FINAL PLAT OF  
"ASHBROOK MEADOWS AT CHISHOLM CREEK"

RE: S/D 98-107 -- One-Step Final Plat of ASHBROOK MEADOWS AT CHISHOLM  
CREEK ADDITION

RE: S/D 98-107 -- One-Step Final Plat of ASHBROOK MEADOWS AT CHISHOLM  
CREEK ADDITION

**CASE NUMBER:** S/D 98-107 - ASHBROOK MEADOWS AT CHISHOLM CREEK

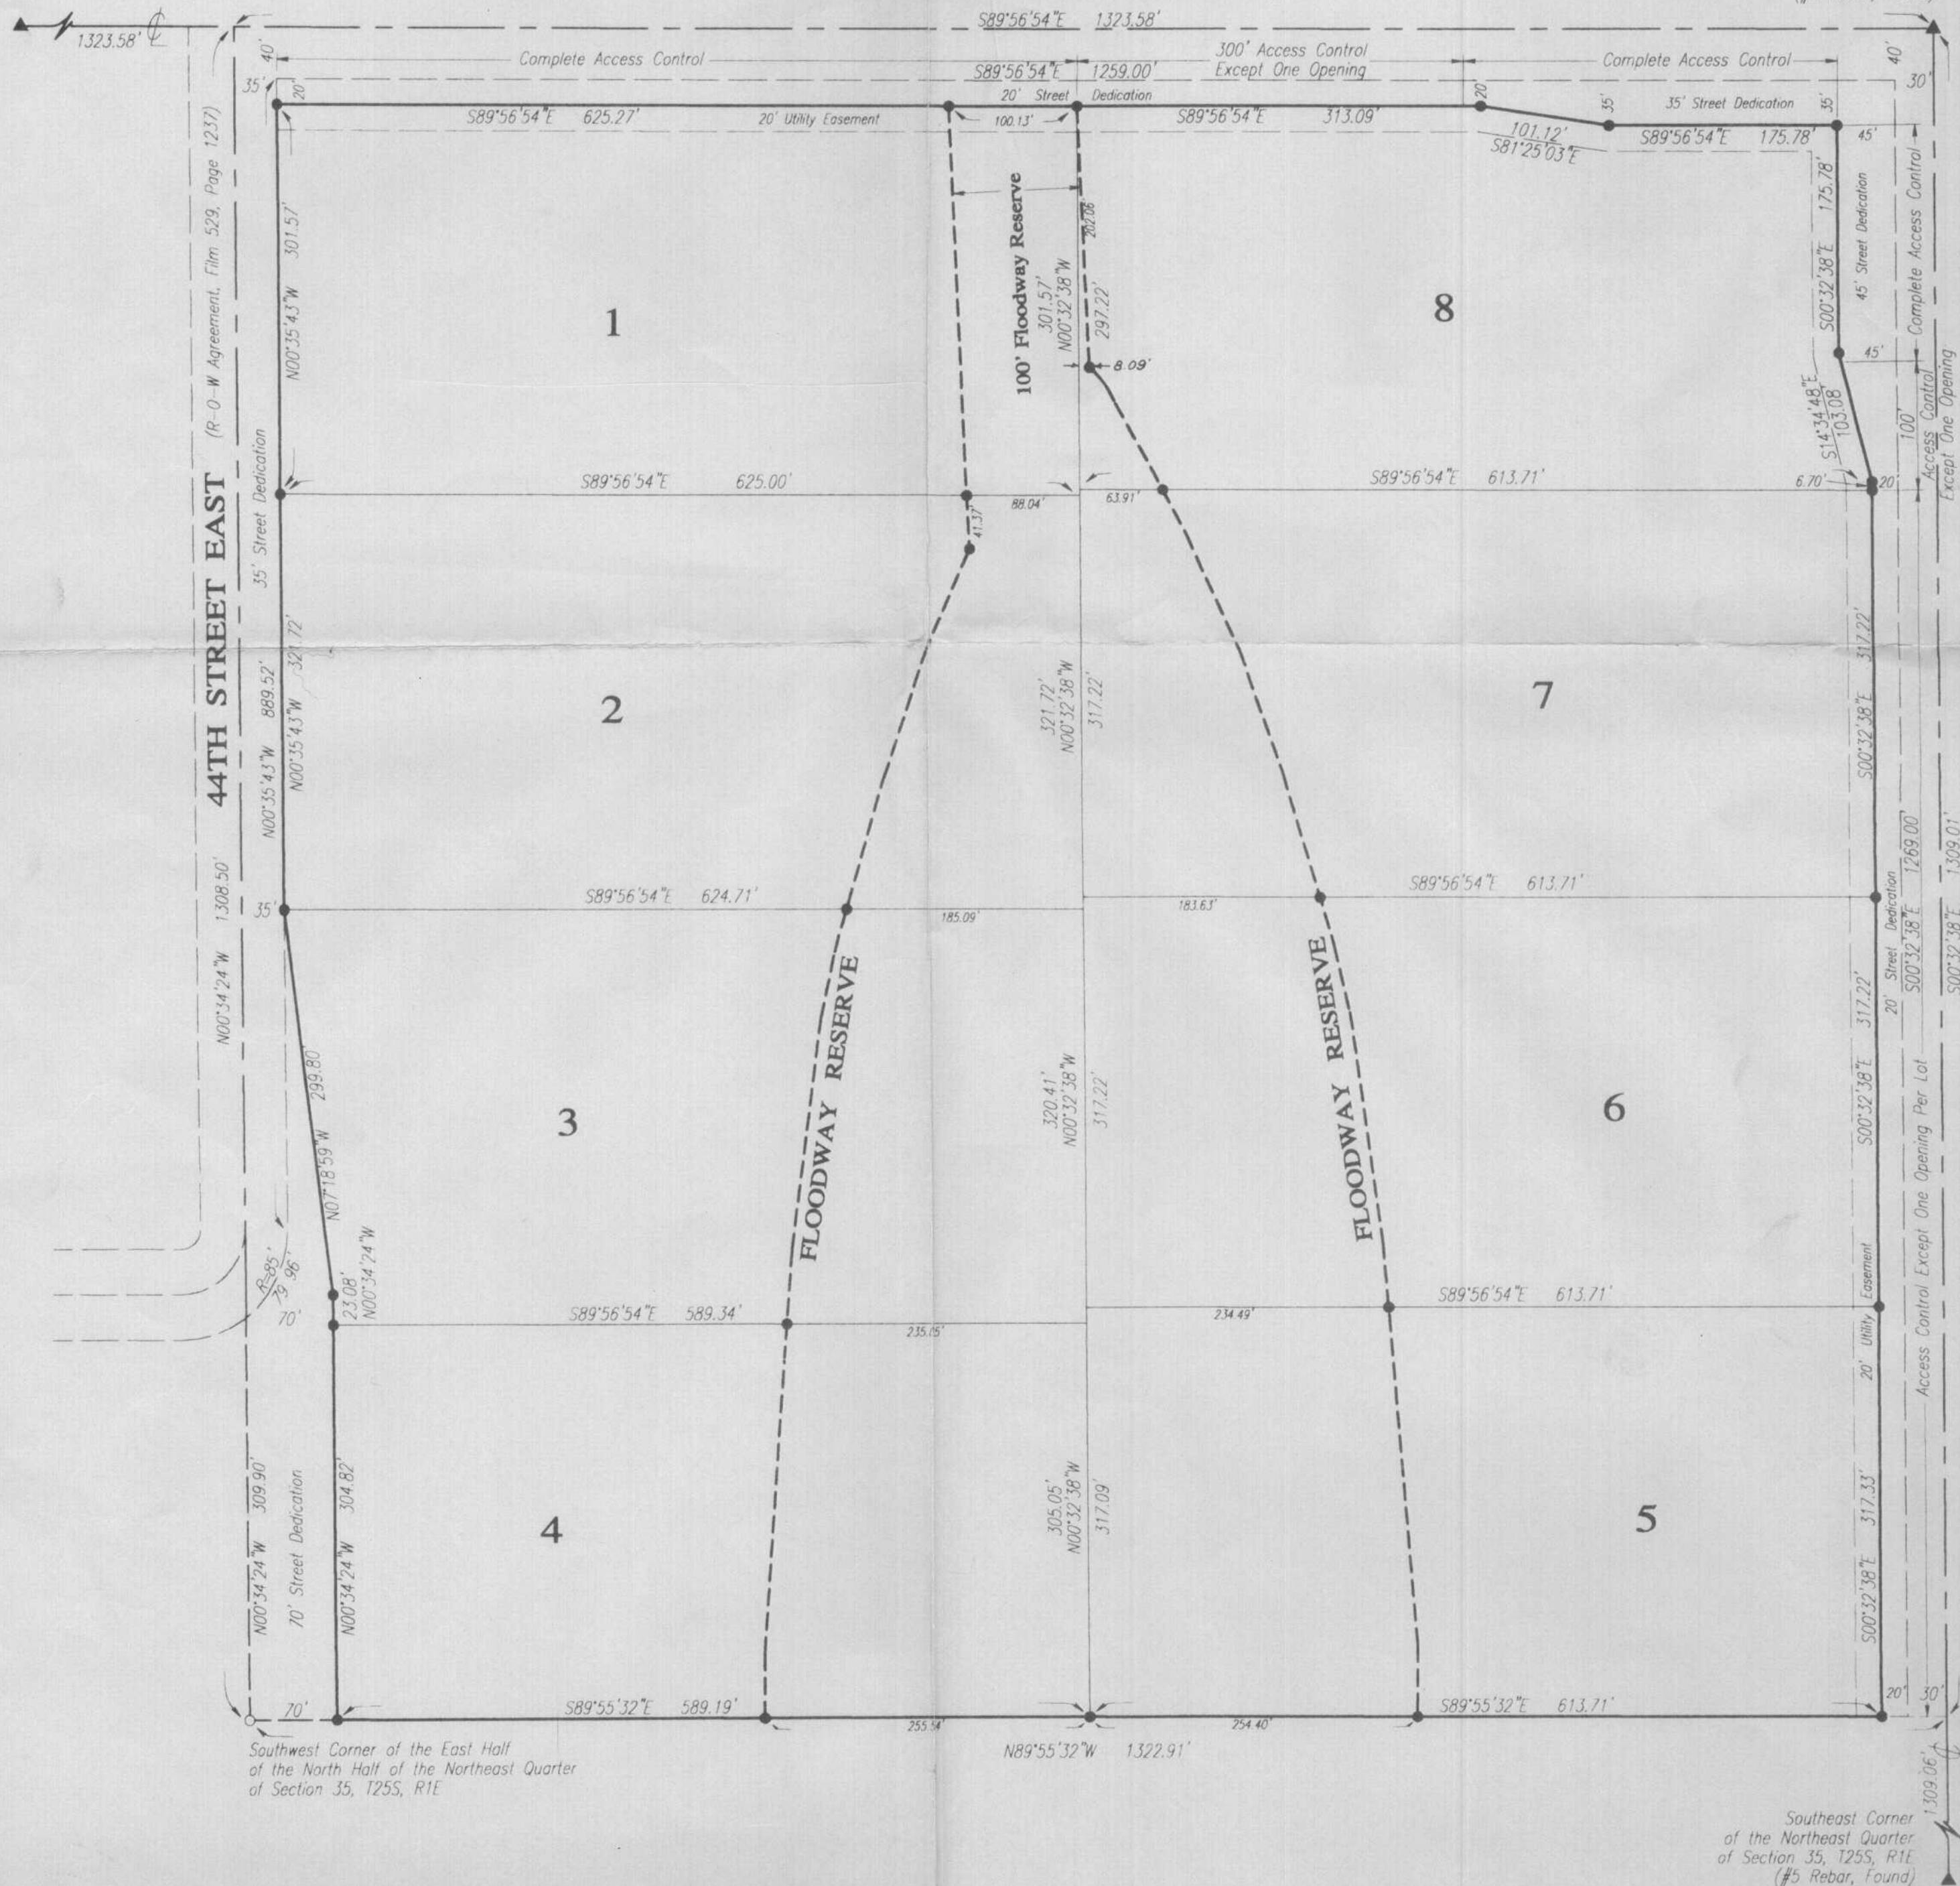
- A. Since neither municipal water nor sanitary sewer is available to serve this property, the applicant shall contact the Environmental Health Division of the Health Department to find out what tests may be necessary and what standards are to be met for approval of on-site sewerage facilities and water wells. A memorandum shall be obtained specifying approval. The lots will consist of less than 4.5 acres, in violation of the Subdivision regulations after dedication of right-of-way for adjoining streets. *The Subdivision Committee has approved a modification to the 4.5 acre minimum lot size.*

- C. County Engineering needs to comment on the status of the applicant's drainage plan. *The drainage plan is approved.*
- D. County Engineering needs to comment on the access controls. The plat denotes one access opening along 85th St. North for the lot adjoining Oliver, and one access opening per lot along Oliver.

- E. The Subdivision regulation require a 50-ft half street right-of-way for section line roads. The plat denotes a contingent right-of-way dedication for Oliver (currently 30-ft half-street right-of-way) and 85th St. North (currently 40-ft half street right-of-way). County Engineering needs to comment on the need for an outright dedication. *An outright dedication of right-of-way is required for Oliver and 85th St. North.*

- ✓ G. The City Council signature block needs to be added as this plat is located within three miles of the City.
- ✓ G. The applicant shall install or guarantee the installation of all utilities and facilities which are applicable and described in Article 8 of the MAPC Subdivision Regulations. (Water service and fire hydrants required by Article 8 for fire protection shall be as per the direction and approval of the Chief of the Fire Department.)

N. The representatives from the utility companies should be prepared to comment on the need for any additional utility easements to be platted on this property. *Southwestern Bell has requested additional easements.*

**P. An access easement will need to be established for Lot 4.**
